Friends of Poynton Pool (FoPP)

Objections to Cheshire East Council's Spillway Improvements Planning Application

December 2023

Figure 4-3 FN Chart plot of societal risk

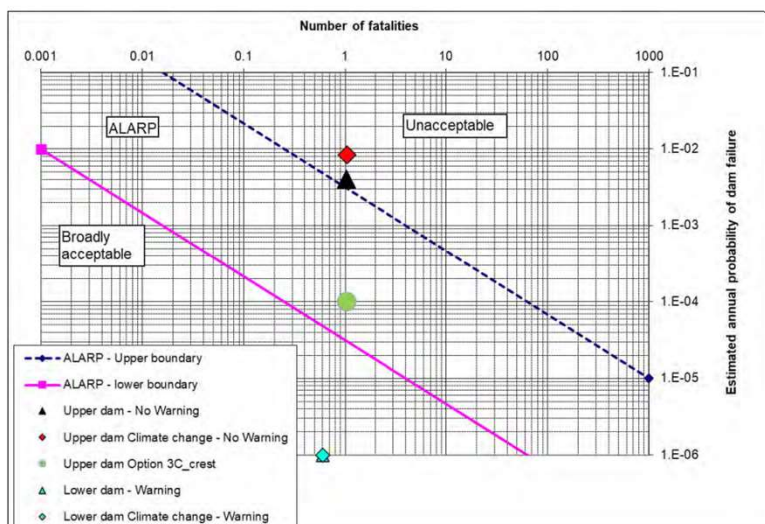
"This indicates the current risk lies within the unacceptable zone".

"Option 3C upper would reduce the risk into the ALARP zone; which is the range where individuals and society are willing to live with the risks..."

Figure 4-3 FN Frequency-Consequence Chart plot of societal risk

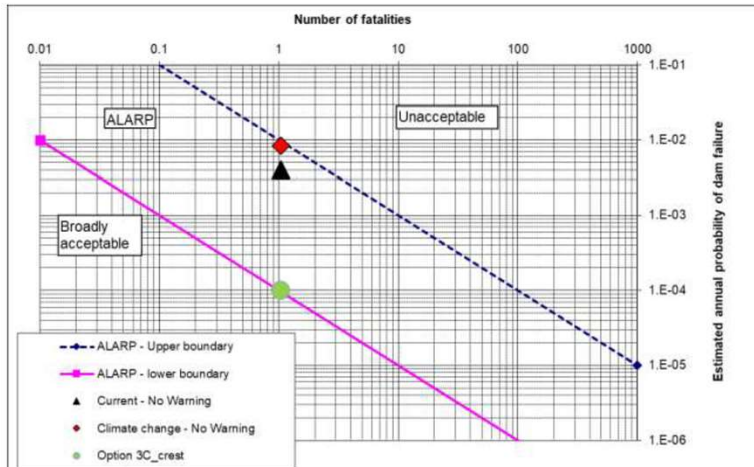
"This indicates that the risk for the upper dam currently lies in the upper part of the ALARP zone where works are justified when the cost is proportionate to the benefits in terms of reduced risk of death and property damage to those living downstream."

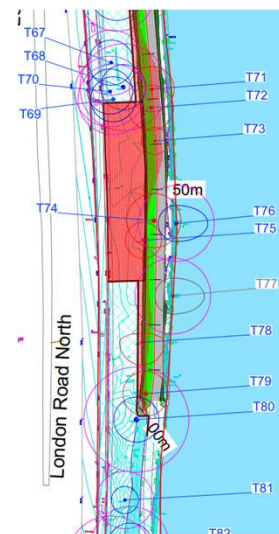
- Clearance of trees to form the two 40-metre-wide areas clear of trees will require the removal of many further trees that are not in the quoted numbers

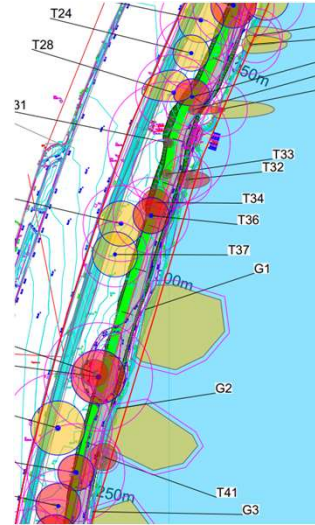
- Other large trees that will be '*compromised – likely lost*' are not even identified in the submission
- Most of the retained trees cannot be protected from ground disturbance and root damage, and many will be damaged by topping and other severe pruning

Figure 4-3: Poynton Lake Reservoir Manually Delineated and FEH Catchment Boundaries

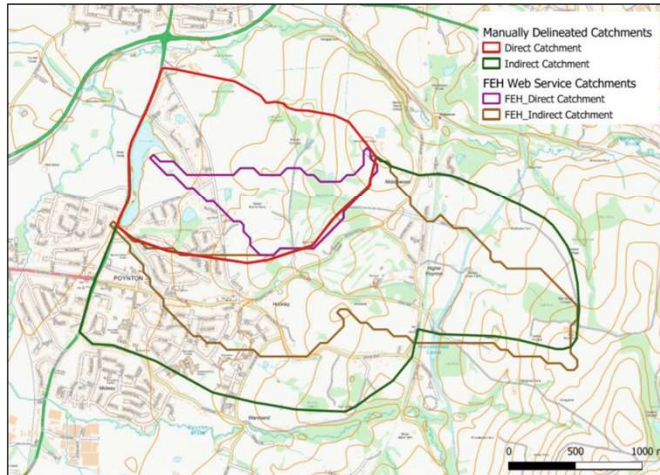
- Jacobs' modelling used a far more appropriate 1 in a thousand years rainfall event (T1000)
- The EA NFM screening fails to allow for the physical reduction of flood surge's heights and their longer durations downstream.
- **Jacobs has almost doubled the catchment area from that recorded on the official National Database for Poynton Pool**
